Access Compliance Report

Public Rights-of-Way

(Pedestrian Signals)

Intersection ID: N/A	Main Street:	Cross Street: N/A	Location: N/A
ADA ID: 92797C409BE4	Signal Type: One Push Button-Non APS	Overall Compliance: No	Severity Score: BTN 1: N/A BTN 2: N/A No BTN: N/A
Codes/Mitigation Info/Possible Solution		Field Measurements/Component Compliance

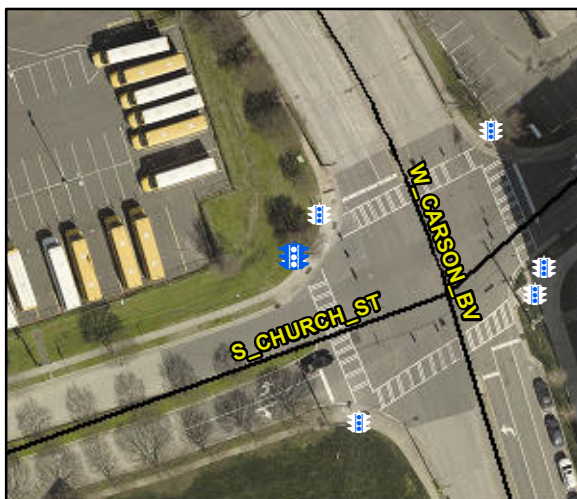
Compliance	Description	Data	Compliance	Description	Data
	Button Count	Button1	Yes	Distant to Additional Button (in)	303.0
	Additional Button Present?	Yes		Additional Button ID	32E9D41F8429
N/A	Signal Buttons Required?	N/A	N/A	Additional Ped Posts Required	N/A
	How Many Ped Street Xings?	1		Located In An Island/Median?	No
N/A	B 1 Sign Present?	Yes	N/A	B 2 Sign Present?	N/A
Yes	B 1 Sign Purpose?	Yes	N/A	B 2 Sign Purpose?	N/A
Yes	B 1 Sign Lettering & Contrast?	Yes	N/A	B 2 Sign Lettering & Contrast?	N/A
Yes	B 1 Parallel To XWalk?	Yes	N/A	B 2 Parallel To XWalk?	N/A
Yes	B 1 PAR to Button?	Yes	N/A	B 2 PAR to Button?	N/A
Yes	B 1 PAR to XWalk?	Yes	N/A	B 2 PAR to XWalk?	N/A
Yes	B 1 Clear Floor Space?	Yes	N/A	B 2 Clear Floor Space?	N/A
N/A	B 1 FWD Approach?	Yes	N/A	B 2 FWD Approach?	N/A
N/A	B 1 FWD Approach Constrained?	No	N/A	B 2 FWD Approach Constrained?	N/A
No	B 1 FWD Approach Reach (in)	20.0	N/A	B 2 FWD Approach Reach (in)	N/A

N/A	B 1 FWD Approach Width (in)	N/A	N/A	B 2 FWD Approach Width (in)	N/A
N/A	B 1 FWD Approach Obstruction?	Yes	N/A	B 2 FWD Approach Obstruction?	N/A
N/A	B 1 FWD Approach Obstruction Dist (in)	9.0	N/A	B 2 FWD Approach ObstructionDist (in)	N/A
N/A	B 1 PARA Approach?	Yes	N/A	B 2 PARA Approach?	N/A
N/A	B 1 PARA Approach Constrained?	No	N/A	B 2 PARA Approach Constrained?	N/A
Yes	B 1 PARA Approach Reach (in)	9.0	N/A	B 2 PARA Approach Reach (in)	N/A
N/A	B 1 PARA Approach Width (in)	N/A	N/A	B 2 PARA Approach Width (in)	N/A
N/A	B 1 PARA Approach Obstruction?	Yes	N/A	B 2 PARA Approach Obstruction?	N/A
N/A	B 1 PARA Approach Obstruction Dist (in)	5.0	N/A	B 2 PARA Approach ObstructionDist (in)	N/A
Yes	B 1 Clear Floor Space Slope (%)	6.0	N/A	B 2 Clear Floor Space Slope (%)	N/A
No	B 1 Clear Floor Space XSlope (%)	8.4	N/A	B 2 Clear Floor Space XSlope (%)	N/A
N/A	B 1 PAR Slope (%)	7.5	N/A	B 2 PAR Slope (%)	N/A
Yes	B 1 Height (in)	37.5	N/A	B 2 Height (in)	N/A

Yes	B 1 Clear Xing Direction?	ClearlyMarked	N/A	B 2 Clear Xing Direction?	N/A
	B 1 Crossing Direction	To SE		B 2 Crossing Direction	N/A
Yes	B 1 DistanceTo XWalk (in)	0.0	N/A	B 2 DistanceTo XWalk (in)	N/A
No	B 1 DistanceTo Curb (in)	109.0	N/A	B 2 DistanceTo Curb (in)	N/A
Yes	B 1 Diameter (in)	2.0	N/A	B 2 Diameter (in)	N/A

Possible Solutions: Replace Signal Push Button With APS Button on New Post. Remove & Relocate Sign.
